Addendum No. 2

RFT 24-061 Gymnasium Addition - Glenview Public School

ADDENDUM #1

Project	Glenview PS Gym Addition	Project No.	2314
Location	143 Townsend Ave., Burlington, ON	Date of Issue	2024 05 17
Owner	Halton District School Board	File	2314/7.1.3

Drawing Title:
MILLWORK DETAILS

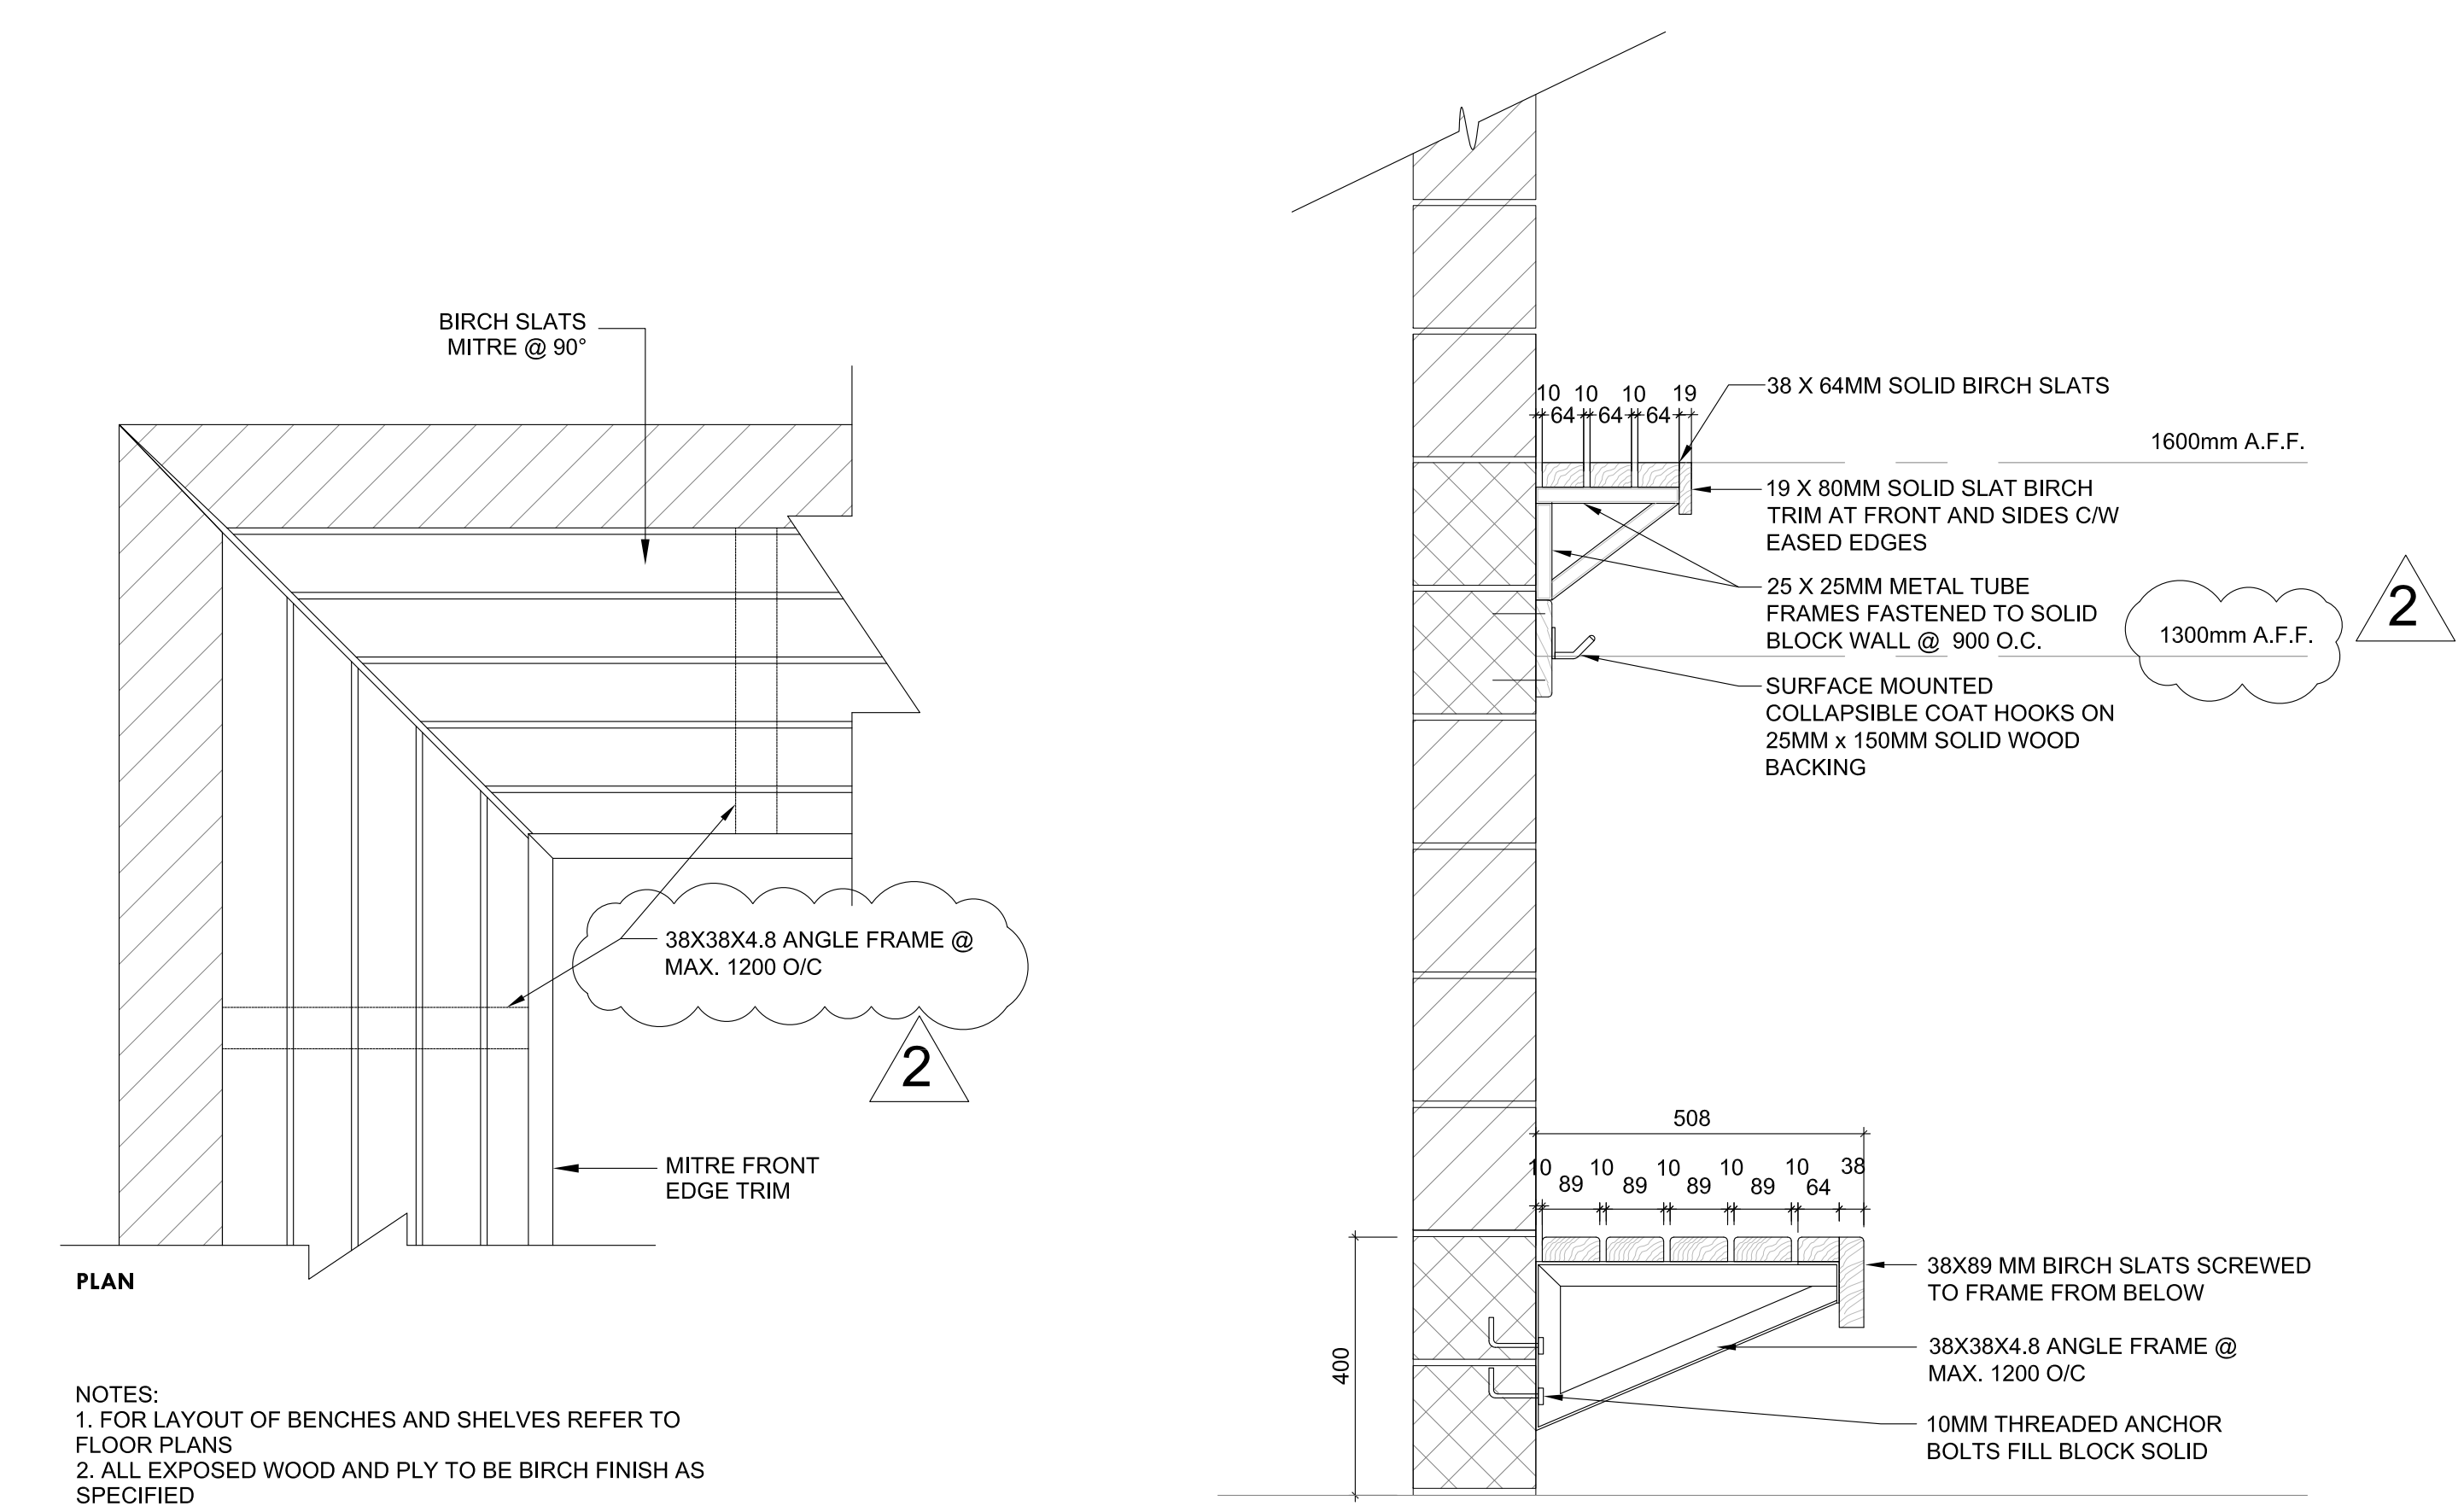
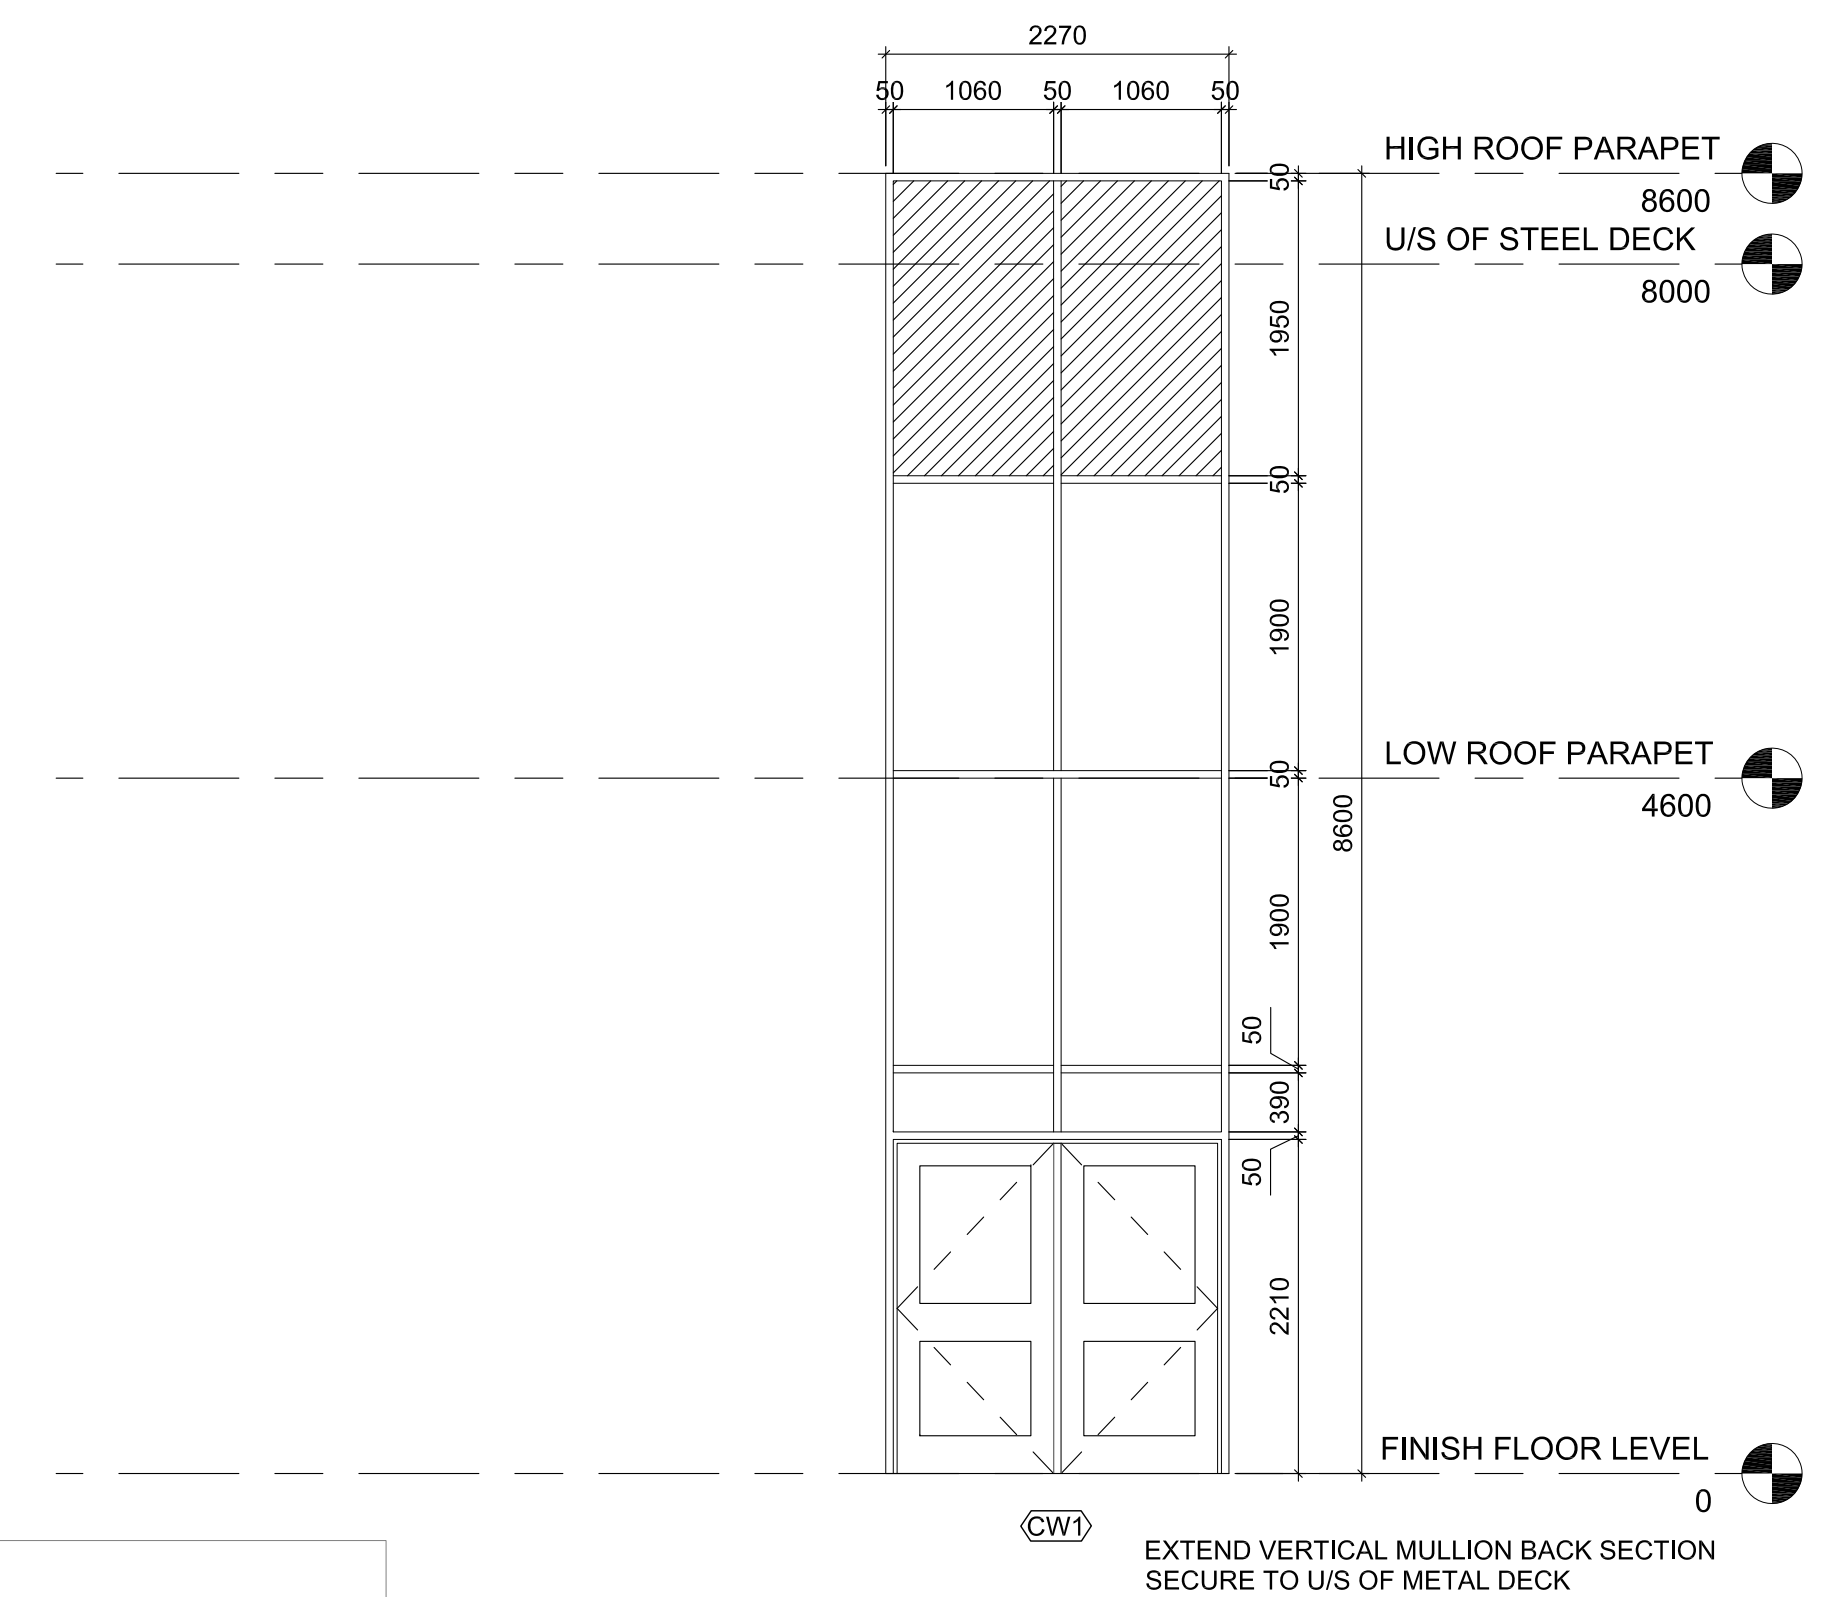
A1-10 DRAWING A801 MILLWORK DETAILS

- .1 Replace Drawing with the attached Revision No. 2.
- .2 Drawing reissued to update 6/A701, 7/A801 and 8/A801.
- .3 6/A801 revised to have enclosure panels wide enough to enclose exhaust hood.
- .4 7/A801 revised to confirm the hook elevation as 1300mm AFF.
- .5 8/A801 revised to show angle frame brackets in lieu of the continuous steel angles.
